WATERSTONE, Fil. No. 4-Site Plan

Technical Correction-Response to Comments

Re: Waterstone Filing No. 4
Site Plan Comments and Technical Corrections
Aurora, Colorado

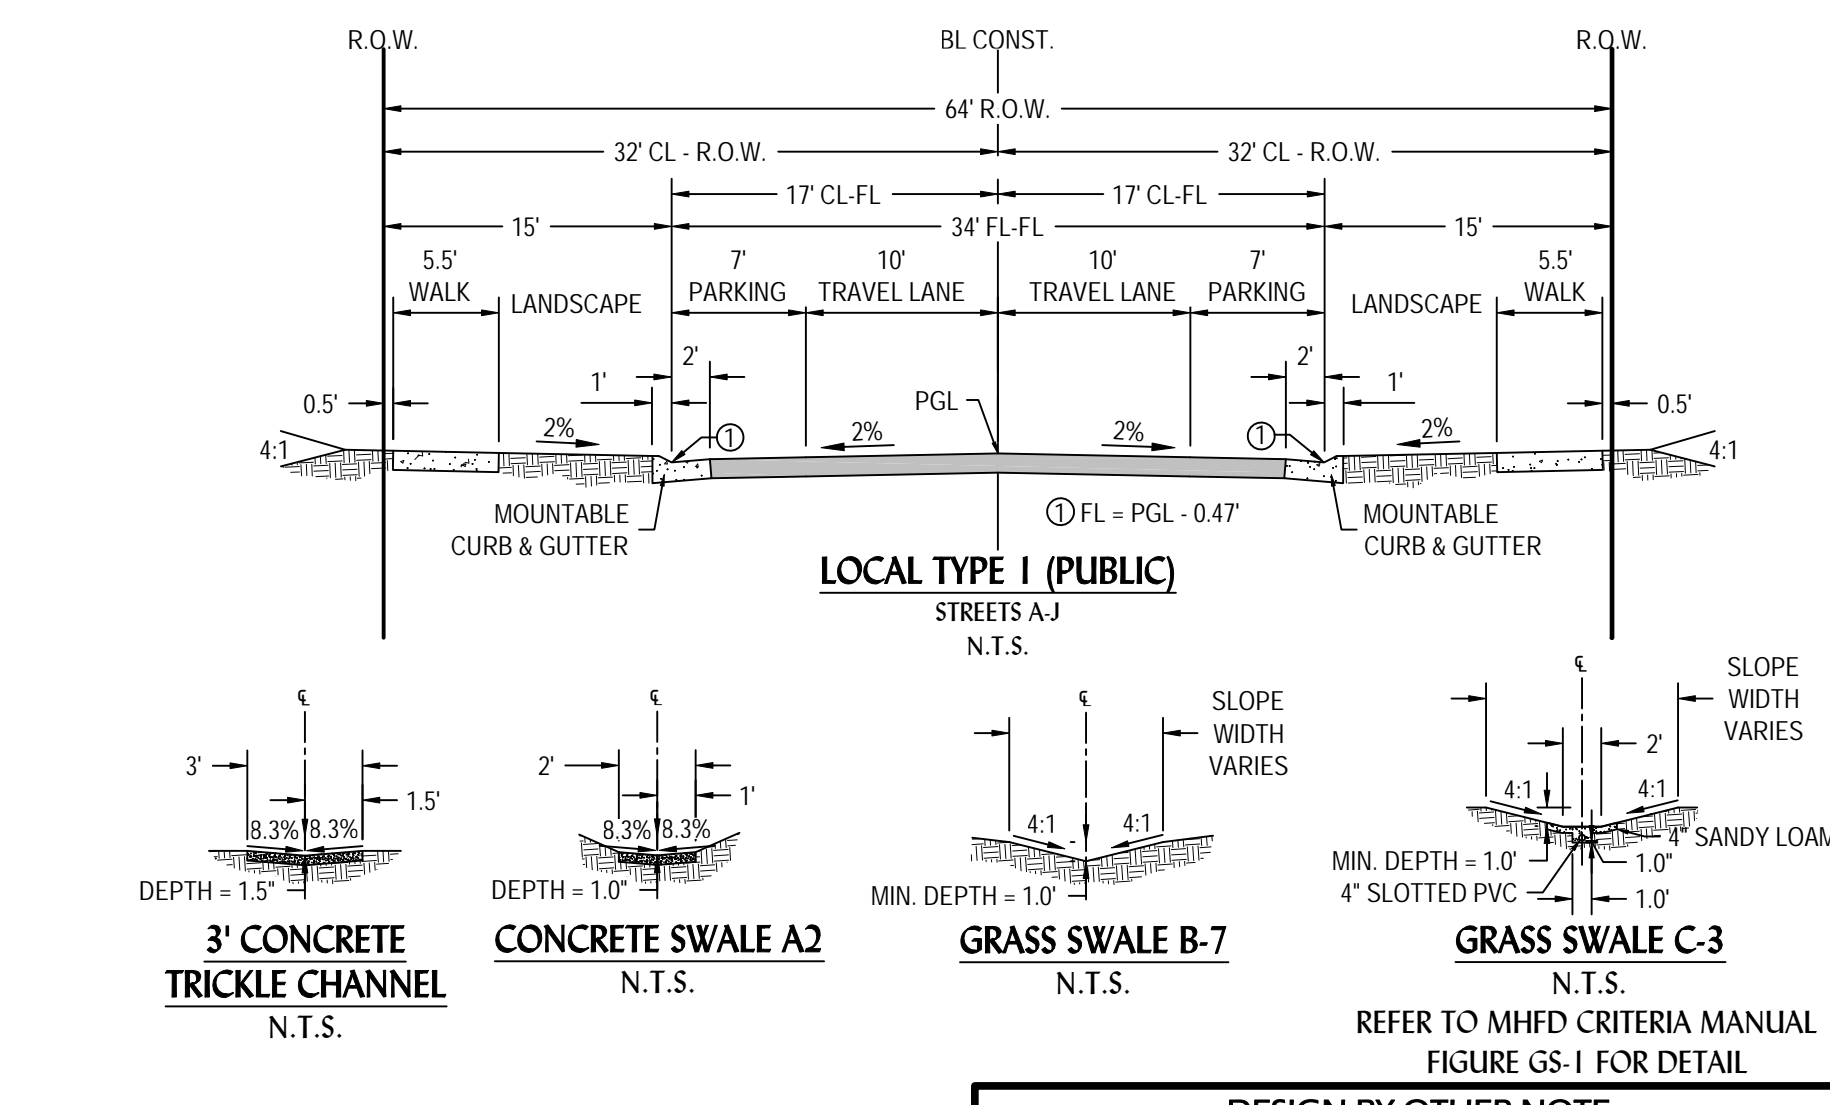
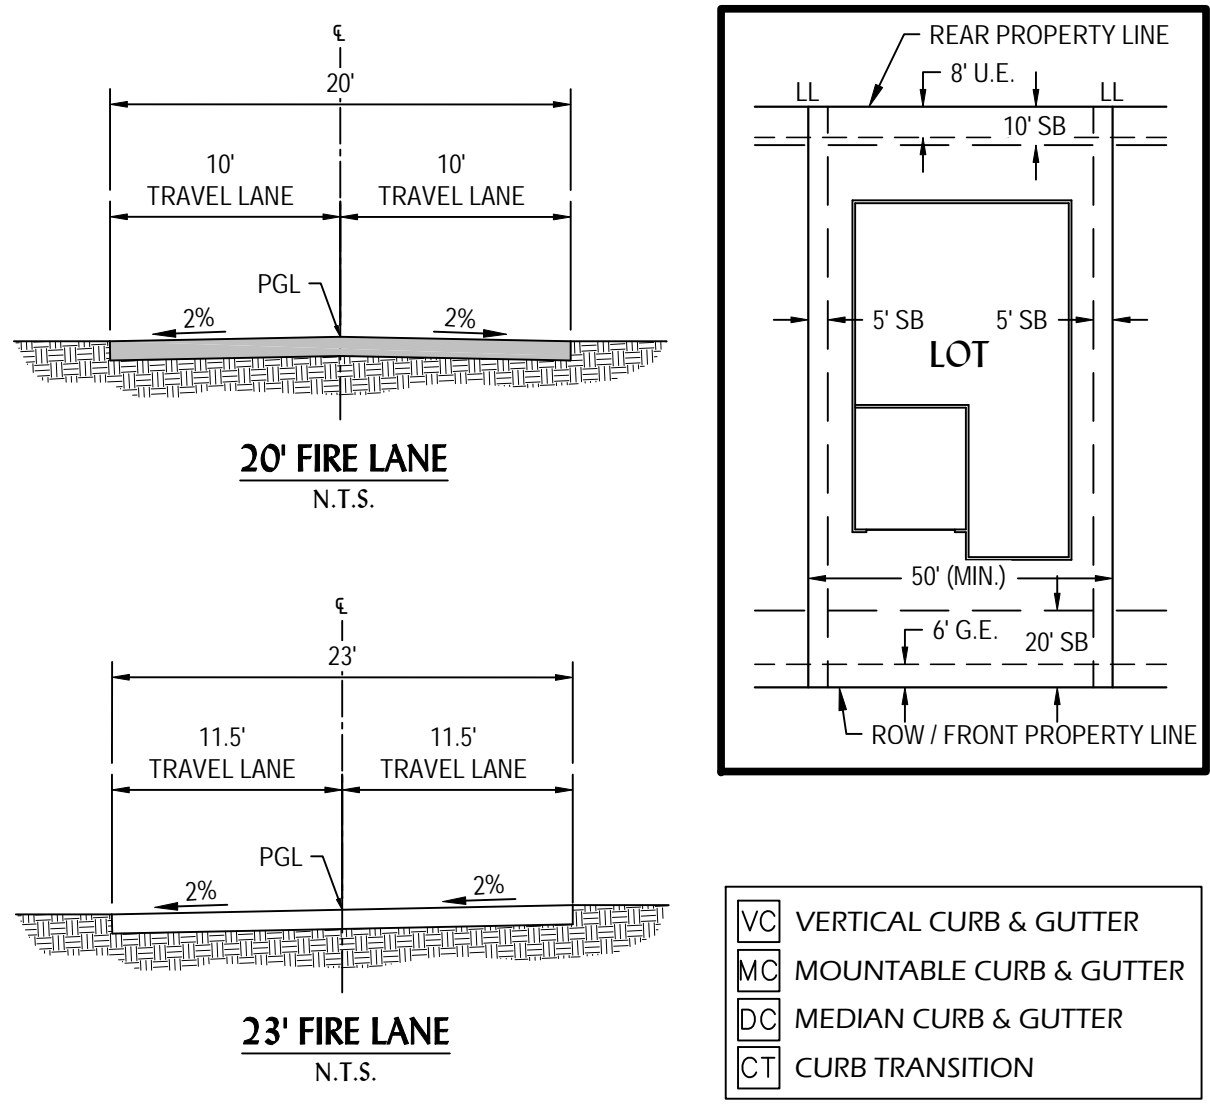
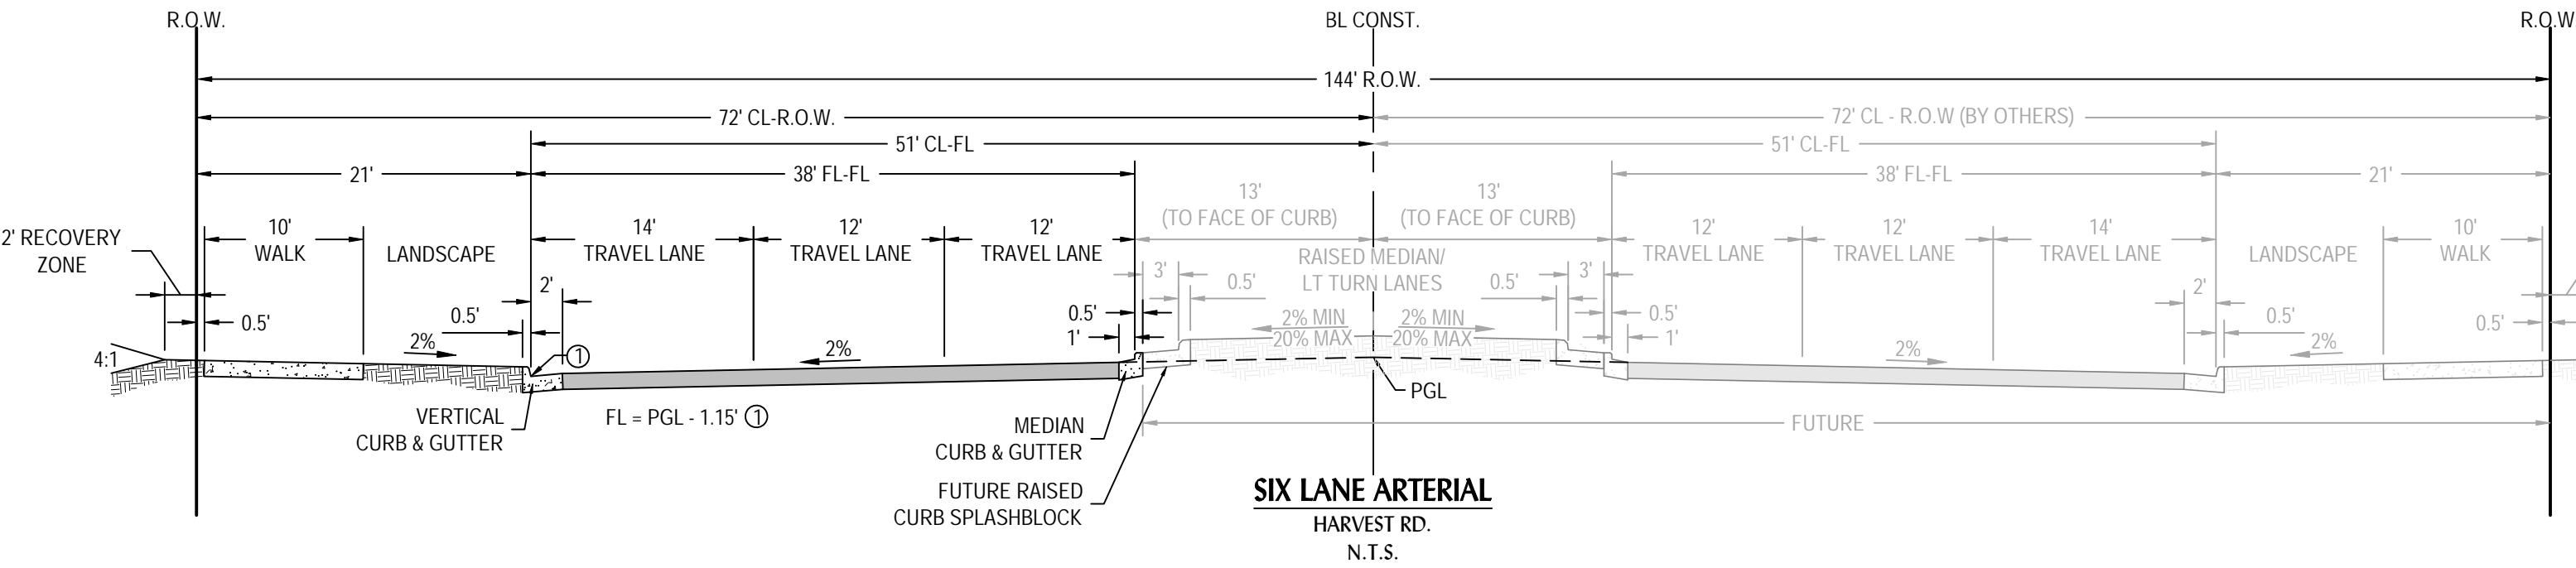
Provide a separate table which lists what areas are being used to meet the required open space/ neighborhood park credit. Similar to the Form J on the master plan. This will help identify what is being credited and what is not.

Repeat comment: If this is proposed for credit toward open space, it will need to include amenities along with the trail.

Noted. Amenities have been added along the regional trail as requested and the amenities list was added to this sheet to show that.
